ADDENDUM NO. 1:

Date: February 20, 2017

Project: The EDGE Business Resource Center

Architect: Ward Scott Architecture, Inc.

N.T.S.

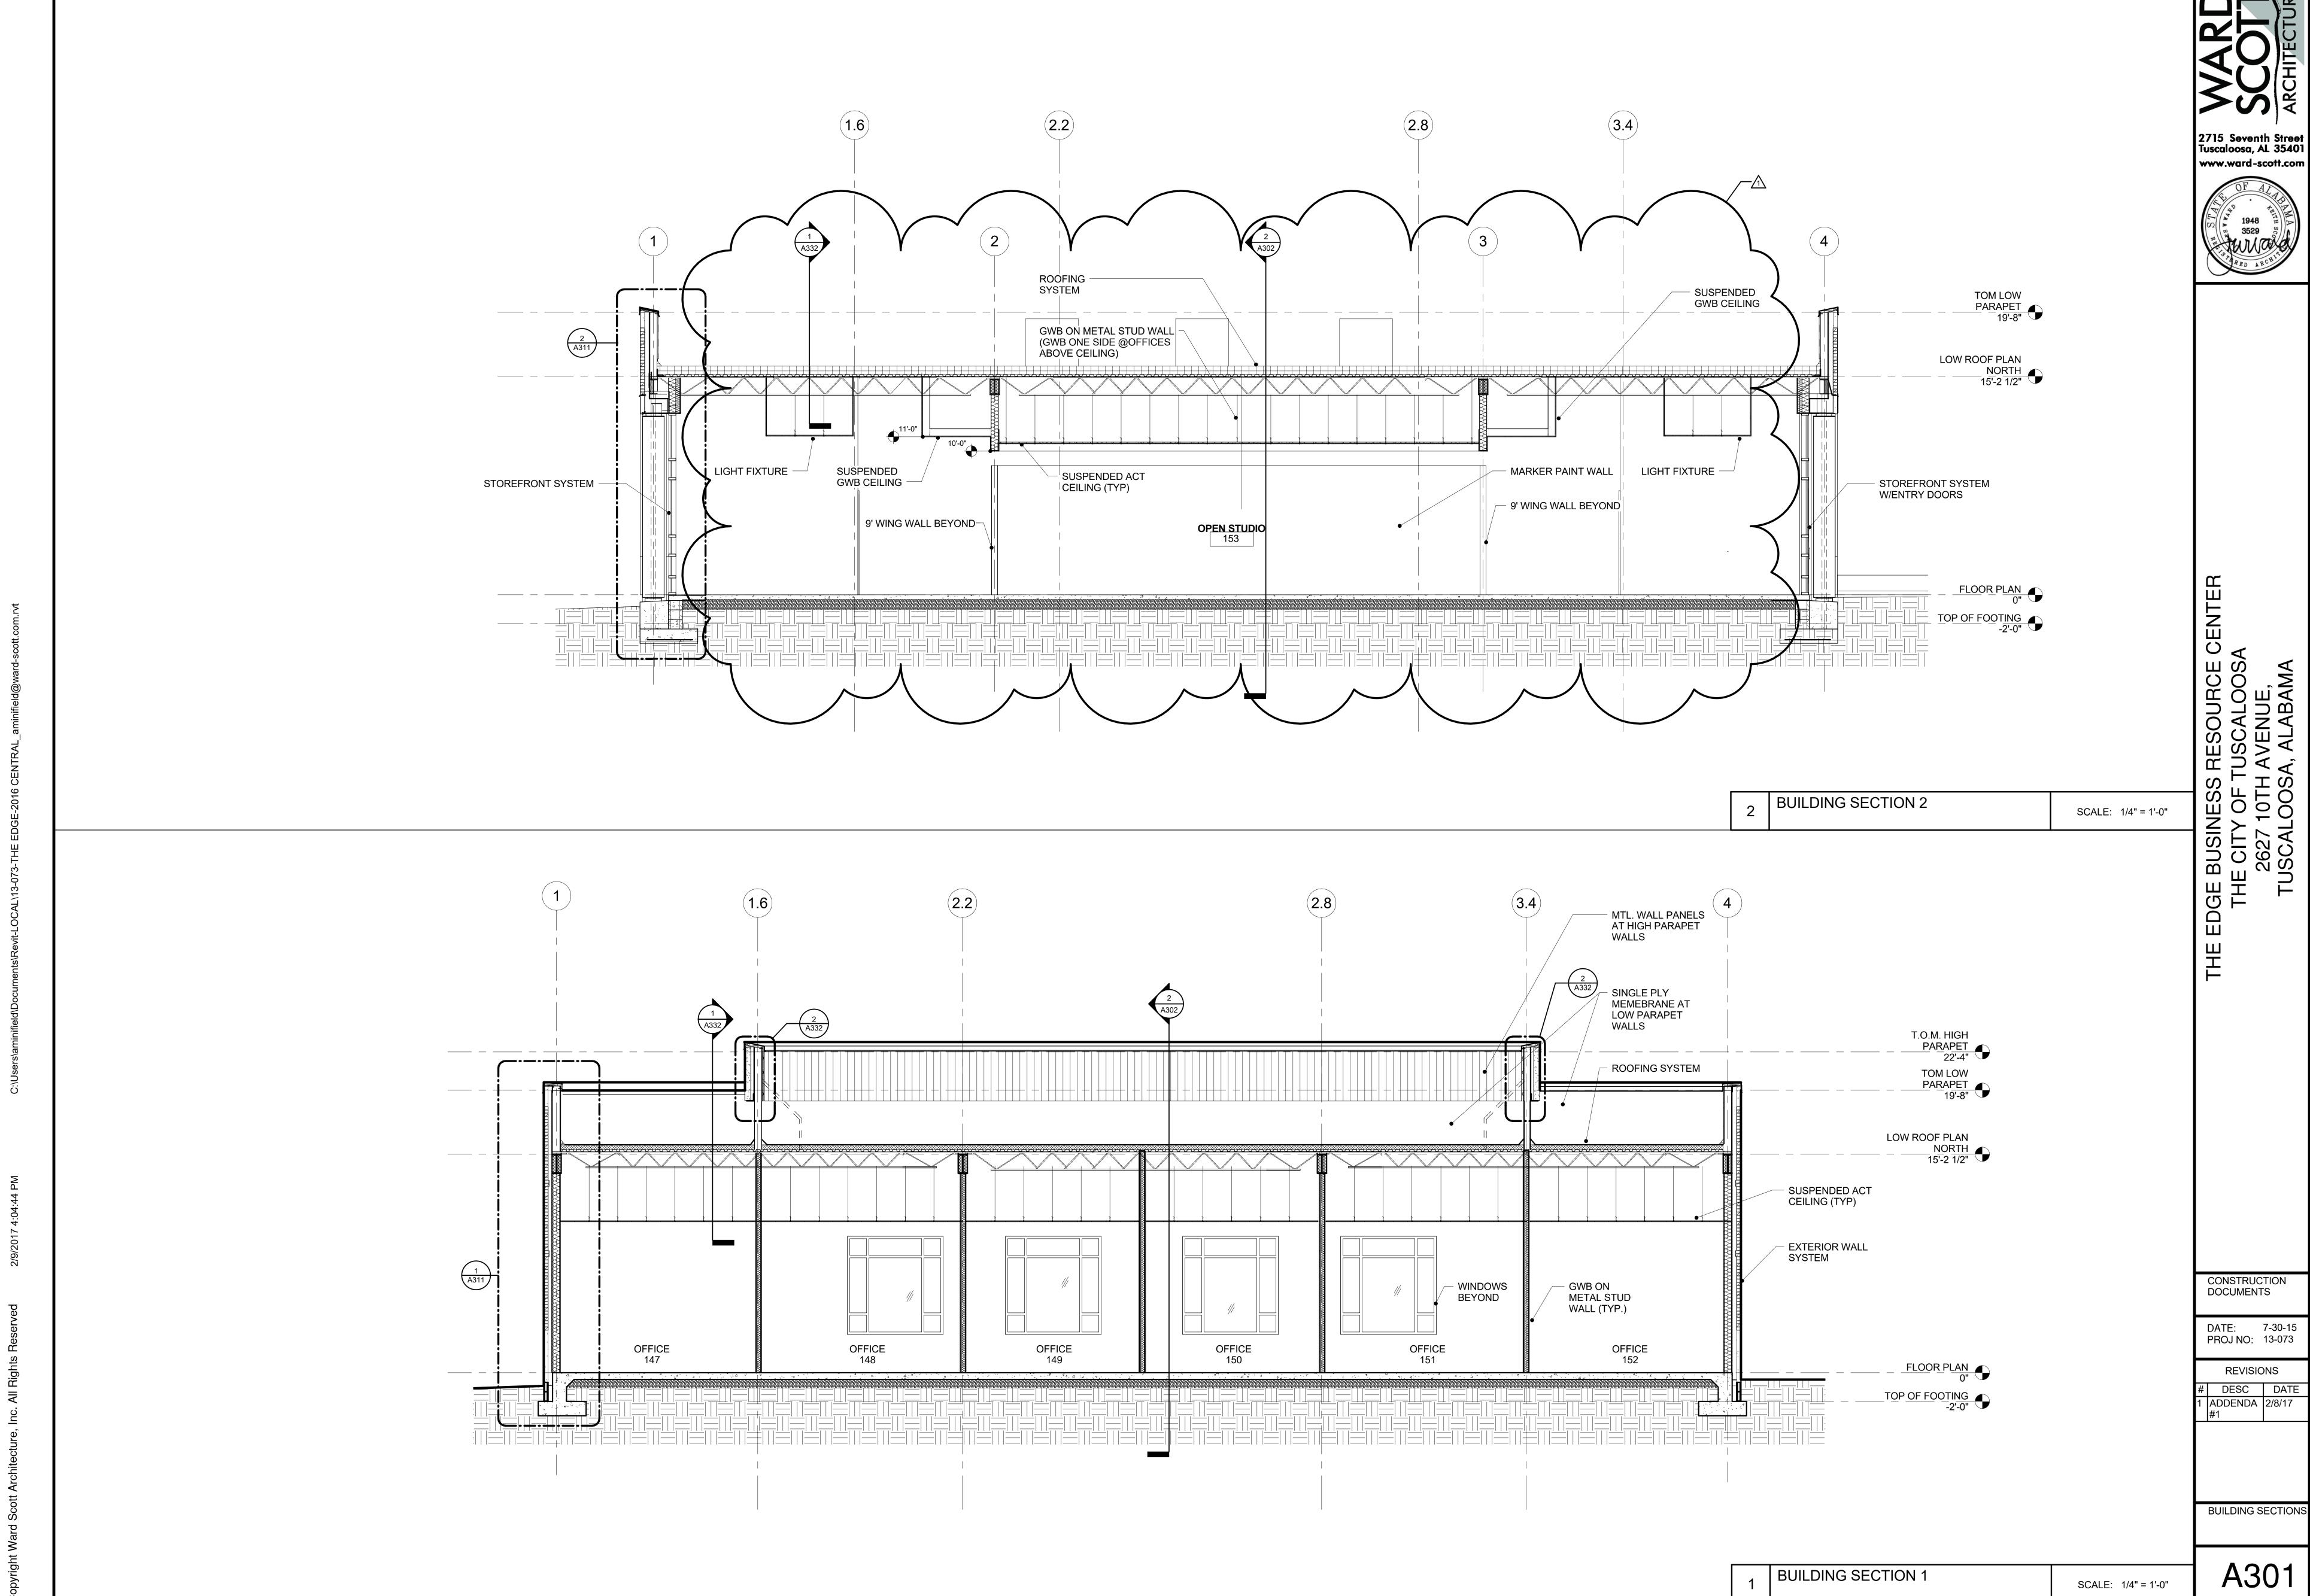
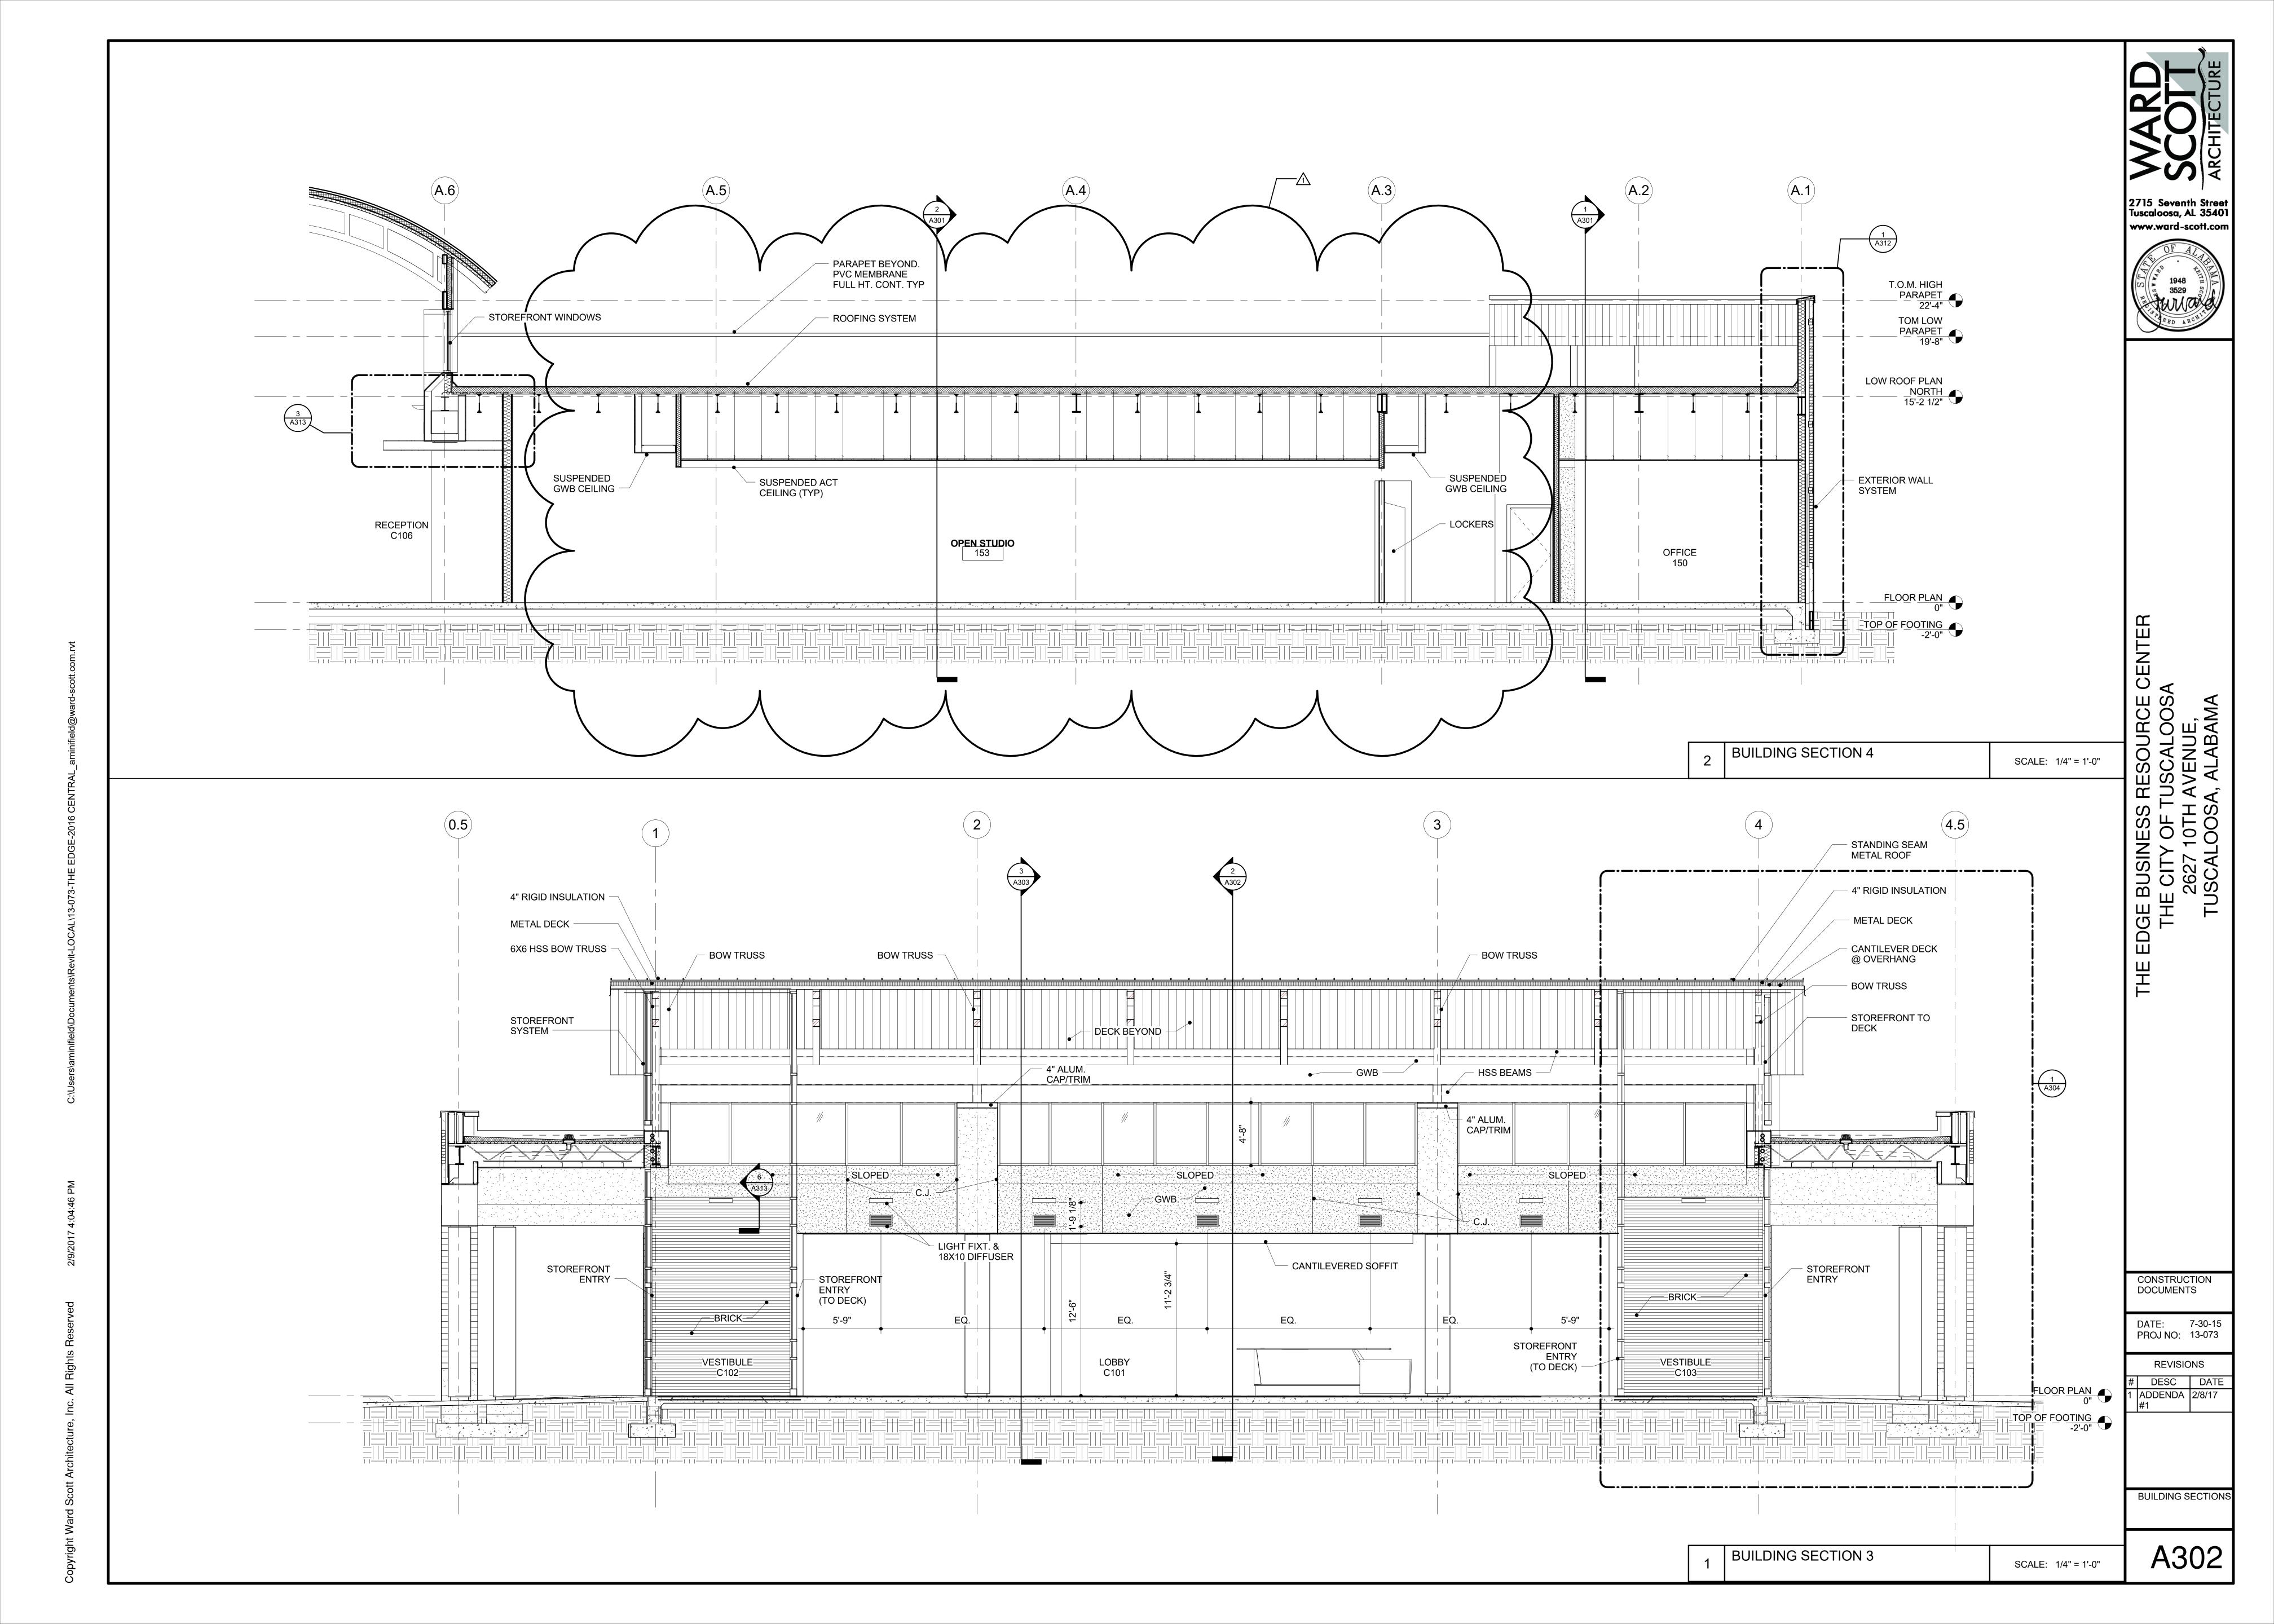
- B. Drawings Revision #1 dated February 7, 2017 Attached Drawings:
 - 1. Refer to Cover Sheet G101. Modify the City Project Number to A16-1320.
 - 2. <u>Refer to Room Finish Schedule Sheet A001.</u> Delete the following rooms and associated room finishes from the Schedule: Open Studio #157, Open Studio #158, Office #139, Office #140, Office #141, Office #142, Office #143, Office #144, Office #145 and Office #146. Modify the finishes for Open Studio #153 as shown on the revised room finish schedule. Add marker paint, #XXXX at Open Studio #153 north wall.

DataCom/Telecom. Audio Visual Floor Plan Drawing DESCRIPTION CHKD. APRD 02.06.17 ADDENDUM

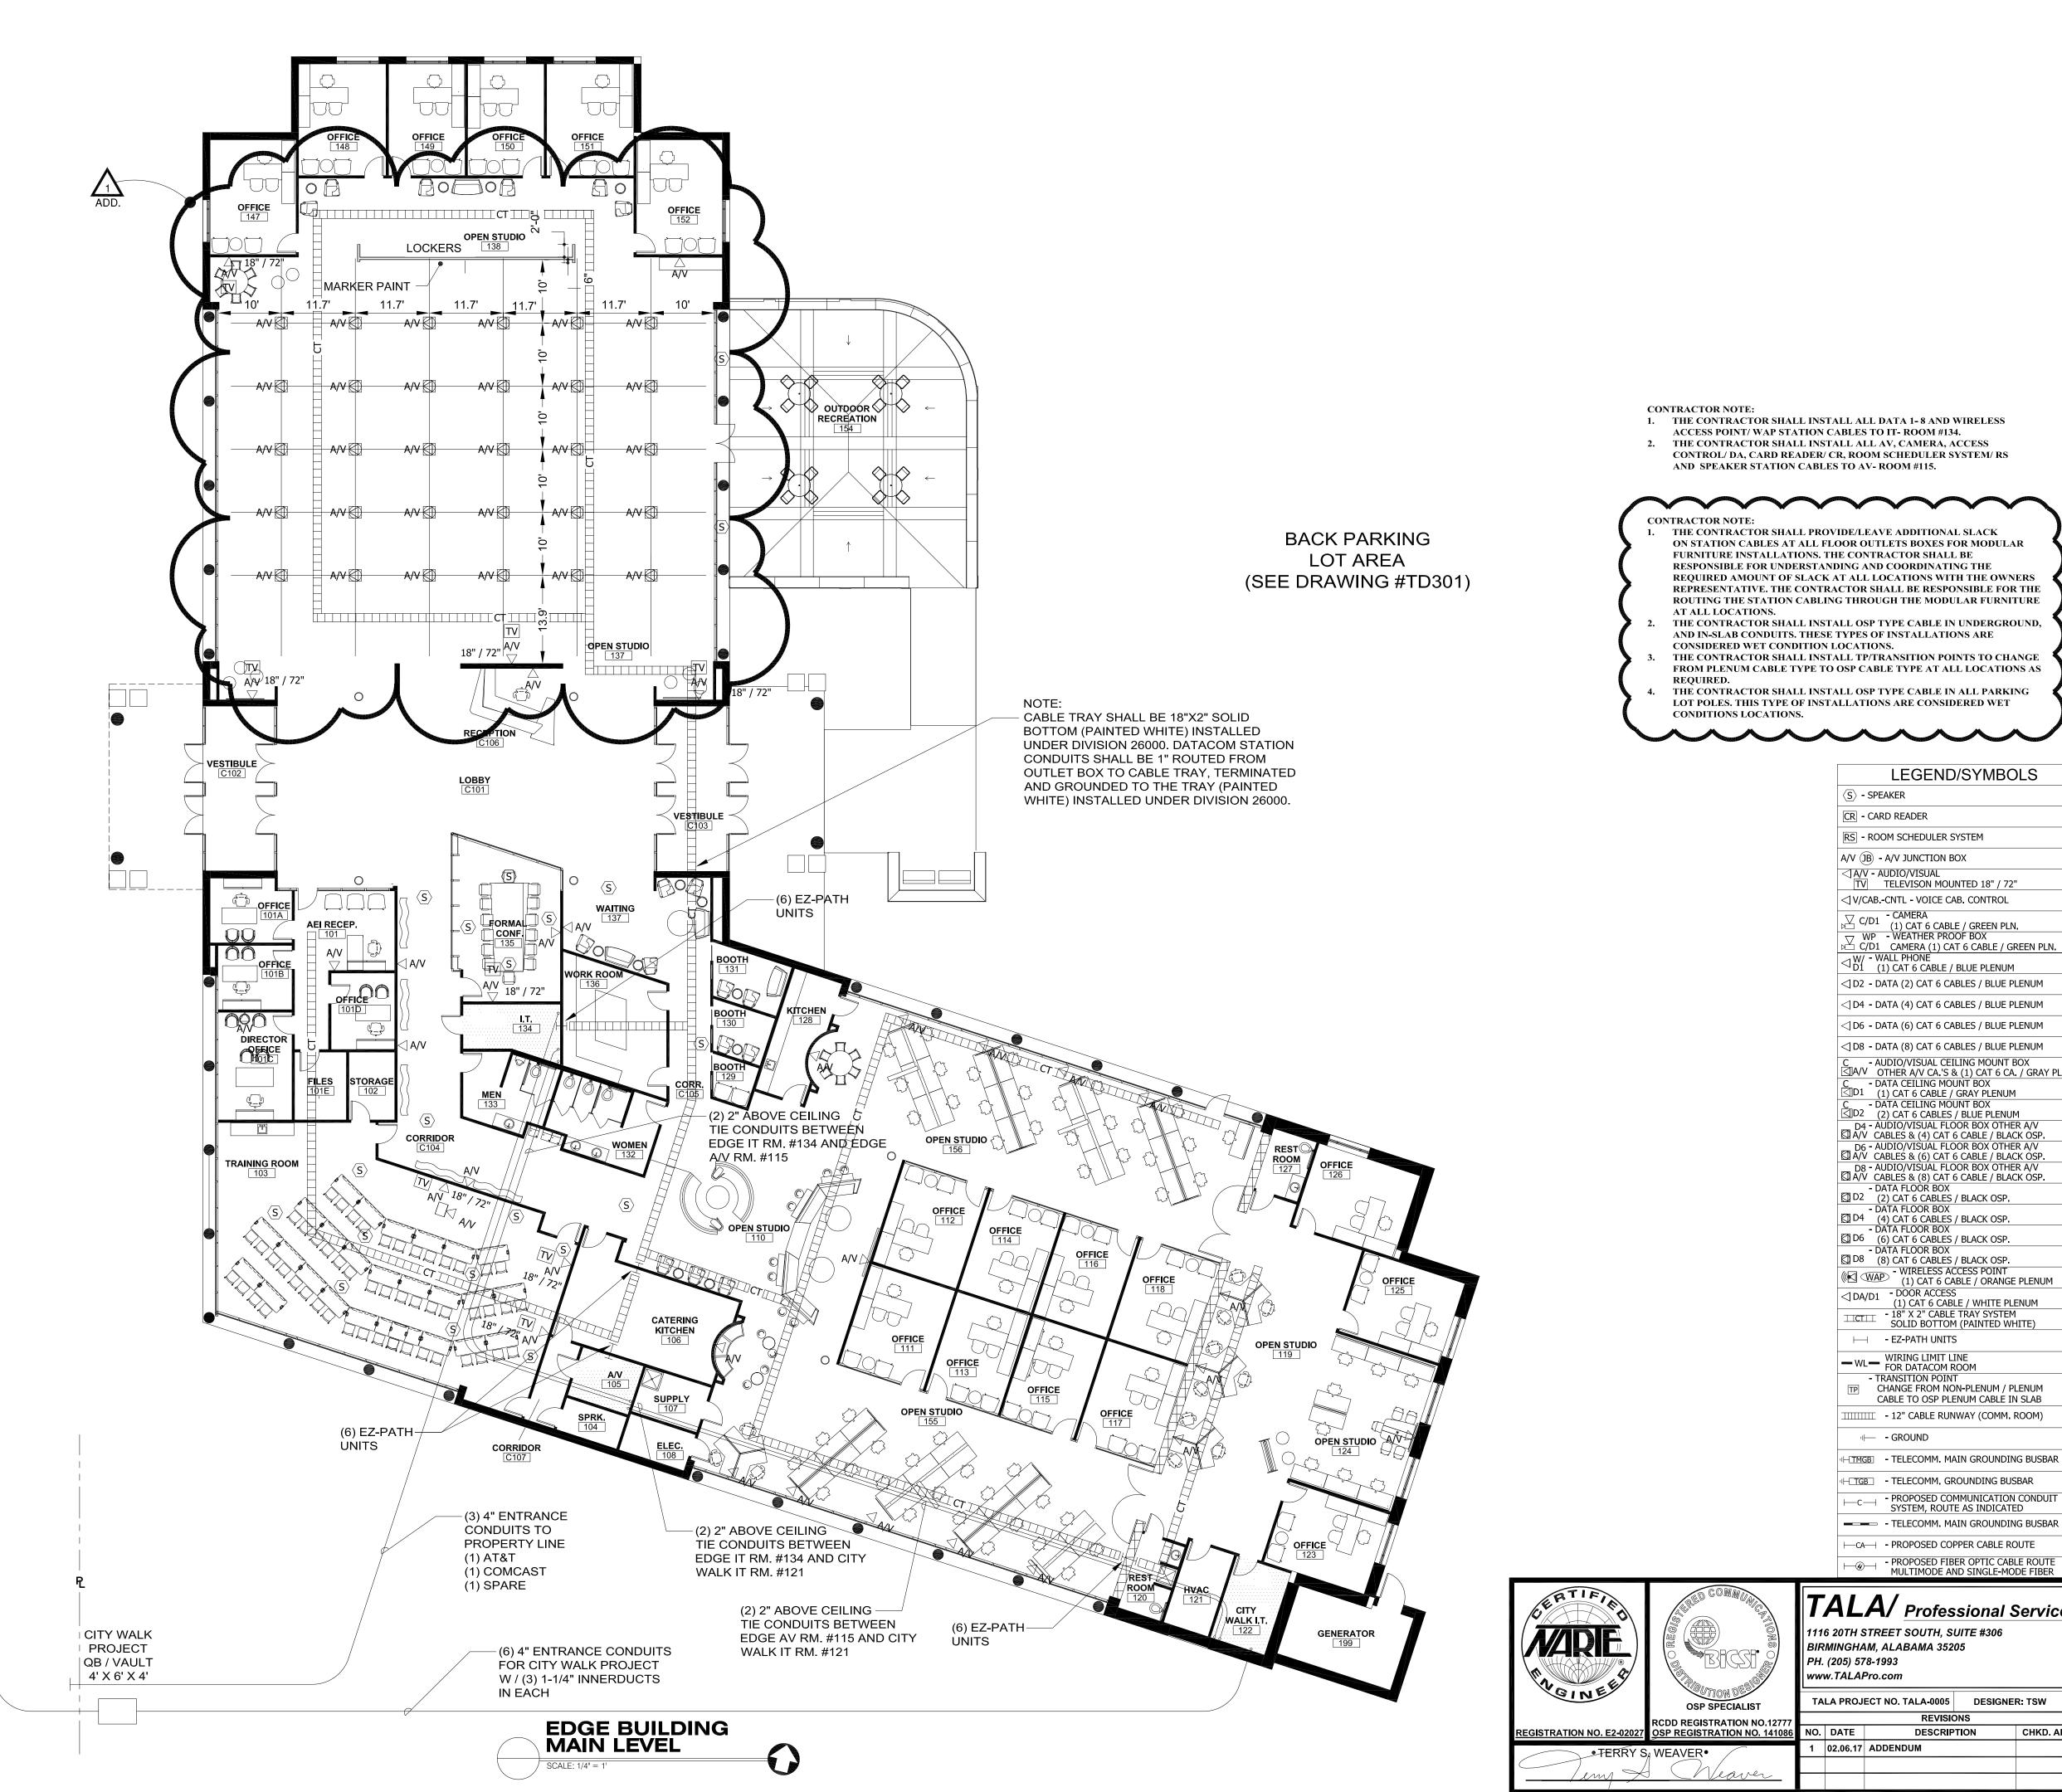
- 1. Re-issued drawing in its entirety. (Replace Drawing TD102)
- 2. Corrected Floor Box Layout on the AV Floor Plan to agree with the removal of offices and changing to the Open Studio #153 North Wing Area.
